1998 - 2001 Corvette Convertible: Service Bulletin: Squeak From Rear of Convertible Top (Replace Protector Assembly)

Number: 01-08-67-003

Subject: Squeak From Rear of Convertible Top (Replace Protector Assembly)

Model Year: 1998-2001 Corvette

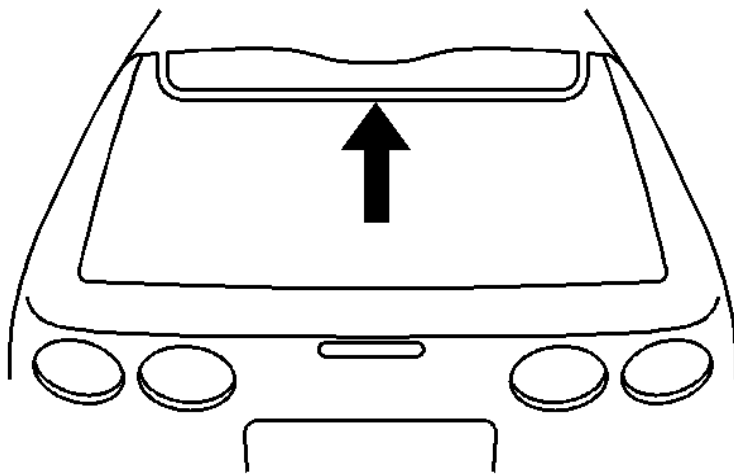
Some customers may comment on a squeak coming from the rear of the convertible top.

This condition may be caused by interference between the fifth bow seal and the tonneau cover rub strip. (Refer to the illustration above).

1. Remove the old seal.
2. Remove any two way tape from the body.
3. Clean the surface.
4. Install a new front top stow compartment lid protector assembly.

Part Number	Description
10313384	Front Top Stow Compartment Lid Protector Assembly
